Our Ref: PL/26/0502  
Your Ref:

**RE: PROPOSED WORKS TO 2NO. BEECH TREES AND 5NO. YEW TREES AT PINEMead, UPPER WARREN AVENUE, AND 2NO. BEECH TREES AT 7 UPPER WARREN AVENUE, CAVERSHAM, READING - PART OF A2 & A1 RESPECTIVELY OF TREE PRESERVATION ORDER NUMBER 339.**

Figure 6 - T4 Beech: previous pruning points to be reduced back to (blue arrows); indicative reduction back to these previous pruning points (yellow curve)

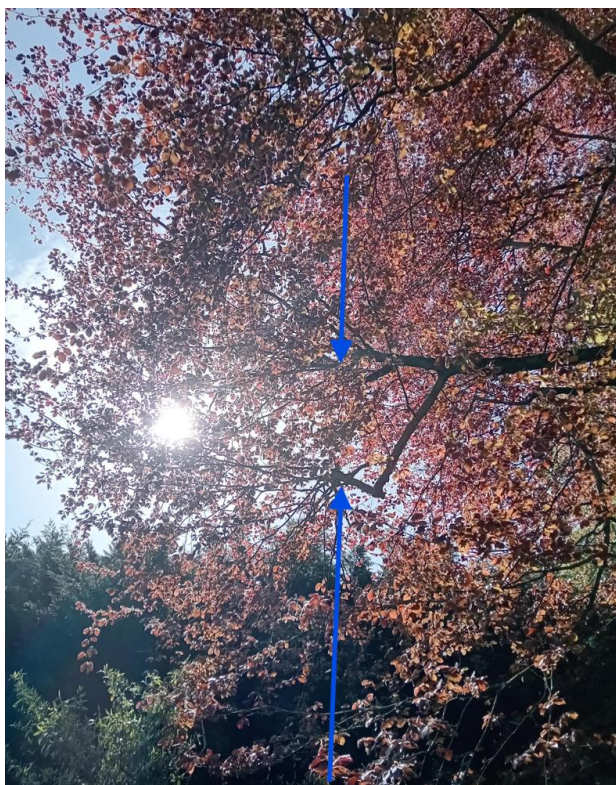
Regarding T2, T3 & T4 Beech trees, which are located in the rear garden, the works are also considered reasonable. These trees have been reduced over the garden previously; hence the reduction should focus on reducing the branches back to previous pruning points. It is difficult to envisage what extremity the 2m would be taken from T2 & T3, and what extremity the 2.5m would be taken from for T4. Hence, we have approved the reductions back to previous pruning points, rather than the lengths of the branches in metres in your application specification. We have also included some additional works to T4, including the removal of 1no. identified, small diameter branch from its source (main stem) and 1no. crossing/rubbing branch. I note that your justification for some of these works includes the shading the Beech trees cause over the rear garden. Whilst this won't eliminate all of the shade, we hope these works improve light availability into the garden, as Mrs Caswell expressed this was desired.

- T4 Beech (rear garden of Pinemead): reduce branches overhanging the rear garden back to previous pruning points, as shown in Figure 6 & 7 below, to form a natural canopy shape, ensuring no more than one third of the foliage is removed from each branch, leaving suitable growth points; remove one identified small diameter branch back to source (see Figure 8); remove one identified crossing/rubbing branch back to source (see Figure 8).
